Reply to Anonymous Referee #2

The manuscript details a study built around stream restoration efforts, and aims to evaluate the effects that large wood placement has on hydraulic habitat for fish. To this end, the authors apply a 2-dimensional hydraulic model, calibrated based on field observations. To assess the relevance of altered channel hydraulics for fish habitat, modeled flow characteristics are linked with empirical information on fish swimming performance and bed material size (to assess its mobility).

Figure R1: Gamma fits to the distributions of shear stress before (A-C) and after (D-F) the additions of LW in sites 1 (A,D), Site 2(B,E) and site 3 (C,F).

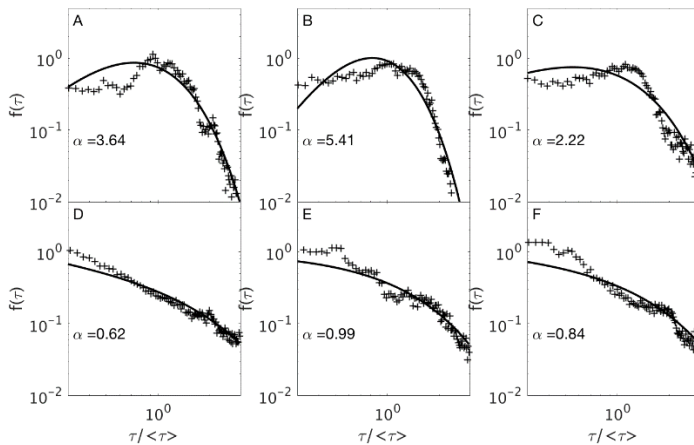
p. 11, line 9: could the authors clarify whether/how gamma distribution was fitted in cases of bimodal data?

Reply: We follow the methodology describe in (Segura & Pitlick, 2015). The parameters of the gamma function that best fitted the distributions were found by systematically varying the α parameter between 0 and 60 in increments of 0.01 (i.e., total 6000 α values tested) and finding the parameter values that yielded the lowest overall χ2 score. We added the mention reference. Given that we are trying to make predictions based in this fits but rather to illustrate the changes in shape of distributions of shear stress we believe there is no need to provide more details here. However, here is a figure of the fits for your review.
